Meeting Date: Tuesday 5 May 2015
Location: Committee Room 2, Level 5, Civic Centre, 1 Devlin Street, Ryde
Time: 5.00pm

**3 325 ROWE STREET, EASTWOOD. LOT 2 DP 18871 Development
Application - Demolition, new 2 storey dwelling. LDA2014/0411.**

Report prepared by: Creative Planning Solutions; Team Leader - Assessment**Report approved by:** Manager Assessment; Group Manager - Environment and
Planning**Report dated:** 8/04/2015**File Number:** GRP/09/5/6/2 - BP15/445

1. Report Summary**Applicant: JLA Architects****Owner: S H Li and T J Li****Date lodged: 22 September 2014 (amended plans received 21 January and
20 February 2015)**

Figure 4 – Plan demonstrating proposed level of overshadowing at 9am on June 21. As can be seen the eastern facing side windows are overshadowed at 9am on June 21 (winter solstice).
Source: Submitted shadow diagrams

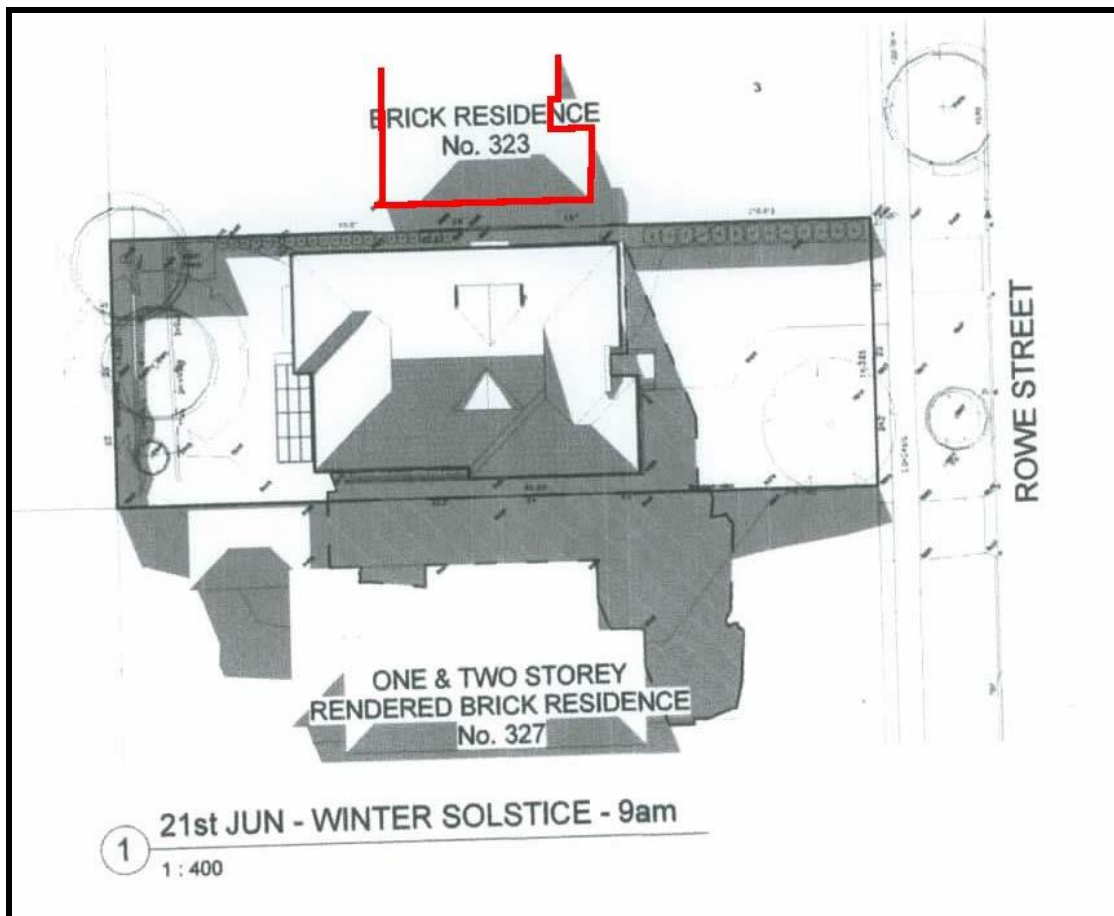
Comment: As demonstrated in the shadow diagrams submitted as part of the development application (refer to **Figures 4-6** below), the proposed development is shown to have some minor overshadowing impacts on the neighbouring dwelling at No.323 Rowe Street, Eastwood between 9am and 3pm during the winter solstice.

It is noted that the submission contends that the dwelling at 323 Rowe Street seems to be in shade for much of the afternoon during the winter months. The shadow diagrams do show that the bulk of the shadows from the proposed development will be cast in the afternoon however these are mainly to the front portion of the dwelling which is also currently impacted by an existing 'lean to' shed within the western side setback of No. 323. The perception of existing shadow impacts may also be due to the existing vegetation located at the rear of the allotments at of No.323 and No.325, in addition to a rear garage to No 323 Rowe Street as shown in the aerial photo (refer to **Figure 1**). After careful review of the solar path and the shadow diagrams provided, it is considered that No.323 Rowe Street would be impacted more from the existing natural and built structures on its own allotment than from shadows cast by the proposed dwelling house at 325 Rowe Street.

Accordingly, neighbouring objections on the grounds of excessive overshadowing are not supported by virtue of the proposal being compliant with the minimum provisions of the Ryde DCP 2014.

Figure 8 – Diagram showing the eastern elevation windows subject to condition of consent.
Source: Submitted elevation drawings

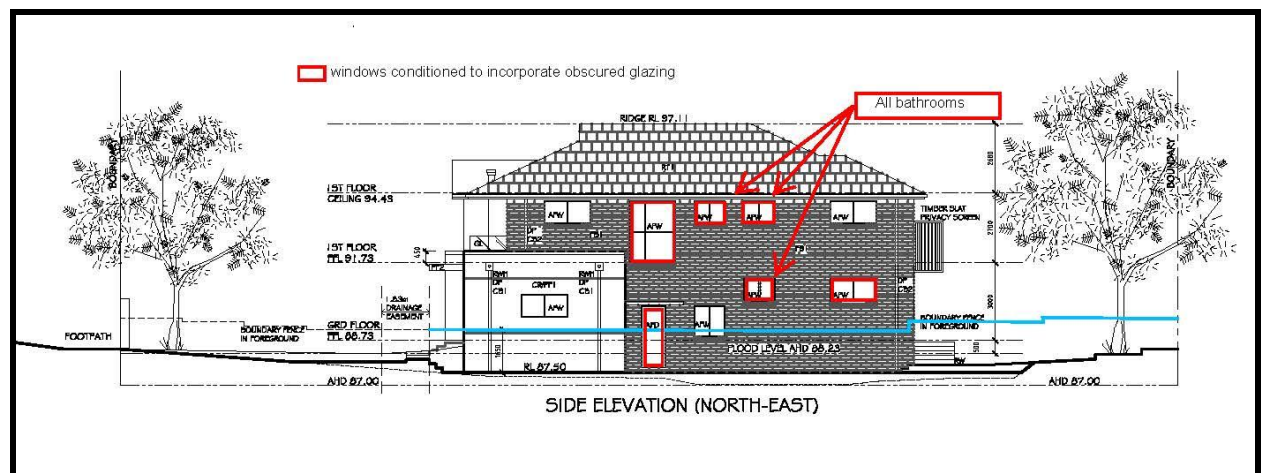
Comment: The objector has rightly contended that there were no measures within the originally submitted plans to prevent the new dwelling from impacting privacy through overlooking of the adjacent dwelling and rear yard at 323 Rowe Street. This was also identified by Council officers in their preliminary planning assessment of the proposal and was detailed in the request for additional information letter sent to the applicant.

Accordingly, it was requested that revised plans be submitted to Council that take into consideration the recommendations and non-compliances with the visual privacy controls of Ryde DCP 2014. More specifically, it was recommended to the applicant that that consideration be given to modify the size, height or dimension of the proposed kitchen window, or install obscure glazing to reduce the potential for overlooking and subsequent loss of visual privacy to adjoining dwellings. In addition the letter recommended that a privacy screen be installed to the eastern elevation of the first floor balcony to reduce the opportunity for overlooking and maintain visual privacy to the neighbouring property's private open space area at 323 Rowe Street.

Accordingly, neighbouring objections on the grounds of privacy impacts from the eastern elevation windows are considered to be satisfactorily addressed by appropriate conditions of consent.

Figure 11 - Proposed streetscape elevation plan showing approximate revised ridgeline (subject to condition of consent to further lower by 90mm) relative to adjacent dwellings
Source: Submitted elevation drawings

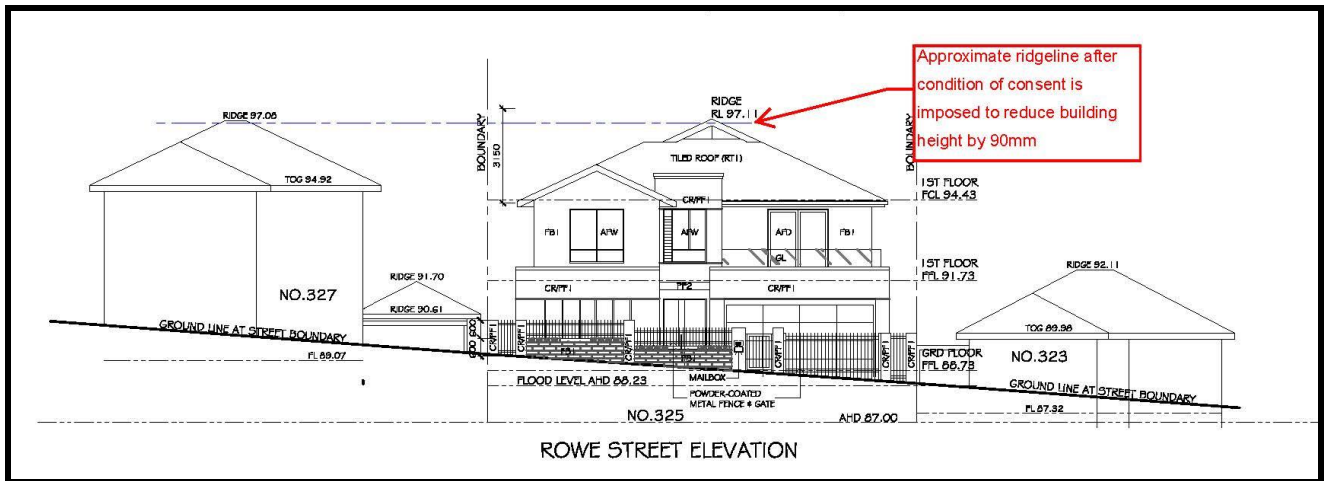
It is noted that a Clause 4.6 Variation was submitted with the revised plans due to a non-compliance of 90mm above the allowable building height of 9.5m. As detailed throughout this report, Council officers do not support this variation to the building height. This is because there is considered to be no valid reason why the proposed development cannot further reduce to the roof pitch to fit below the 9.5m height limit. It is also considered that the Clause 4.6 variation, as submitted, does not sufficiently demonstrate that strict compliance with the numerical control is unreasonable or unnecessary in this instance.

Prior to the issue of a **Construction Certificate**, the following amendments shall be made (as marked in red on the approved plans):

Figure 14 – South west elevation, stair and door to be deleted
Source: Submitted elevation drawings

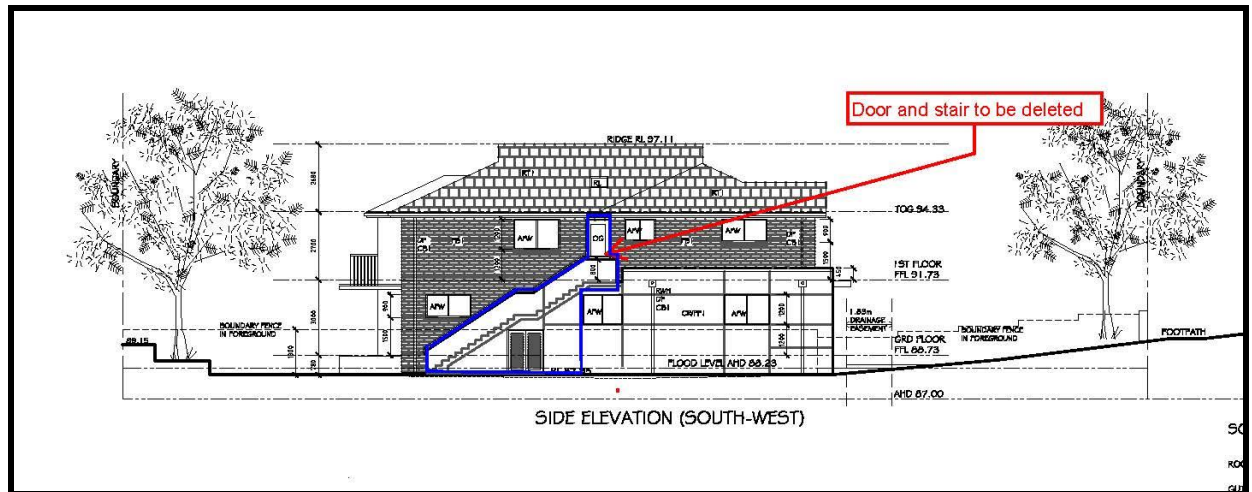
In addition to the above, although it may not be the intention of the applicant, it is considered that the proposed external staircase may give rise to the second level of the dwelling house being reconfigured in a fashion that would allow this level to be utilised as a separate domicile or dwelling.

In order to achieve compliance with Ryde DCP 2014, the proposed external stair will be required to be deleted via the following condition of consent.

Figure 15 – Plan showing trees to be removed. Note that removal of T5 *Jacaranda mimosifolia* is not supported by Council’s Consultant Landscape Architect.

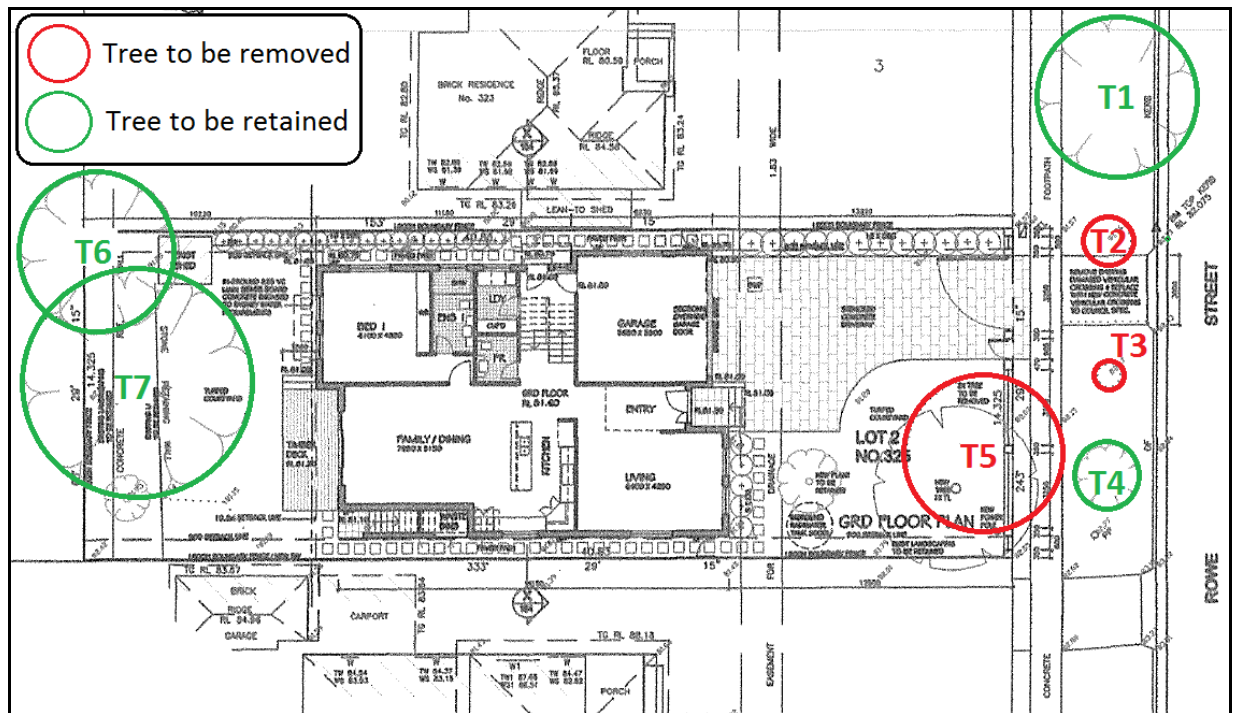
As detailed in the Landscape Referral comments later in this report, the removal of the large *Jacaranda mimosifolia* (Tree 5) within the front yard of the allotment is not supported and is recommended for retention.

Figure 16 – Plan showing solid front boundary fence proposed.
Source: Submitted elevation drawings.

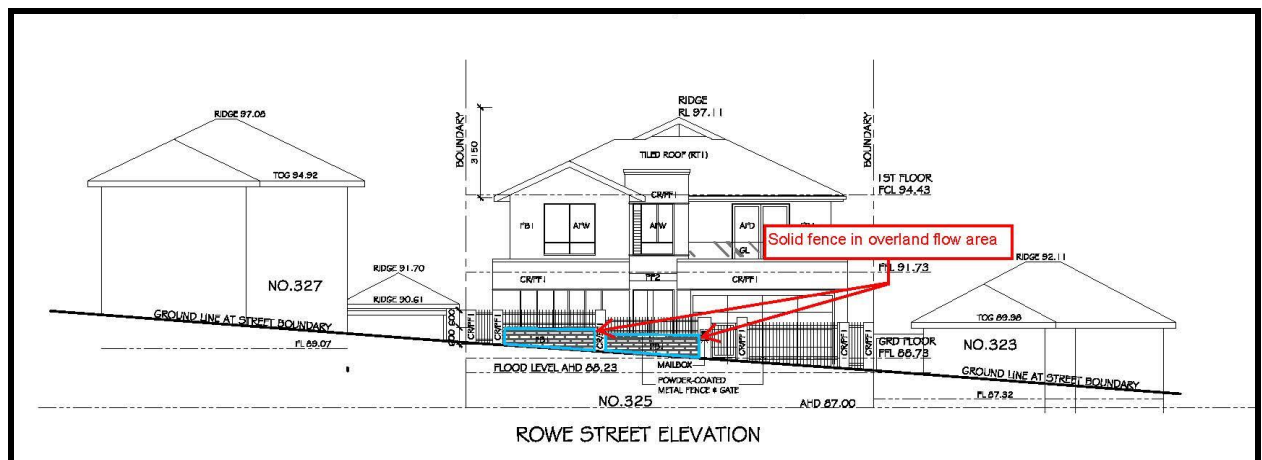
The street elevation plan submitted with the development application, indicate a solid masonry base to the fence to the front boundary.

As the subject site is identified as a site constrained by overland flow, particularly in the front portion of the property, the proposed front boundary fence of solid masonry fence fails to meet the aforementioned control.

Accordingly, a condition of consent has been imposed by Council’s Senior Development Engineer to ensure fencing meets the controls set out within Section 2.15 of Part 3.3 of the Ryde DCP 2014 and does not impede the overland flow path. This condition is described below and included under the Development Engineer referral comments.
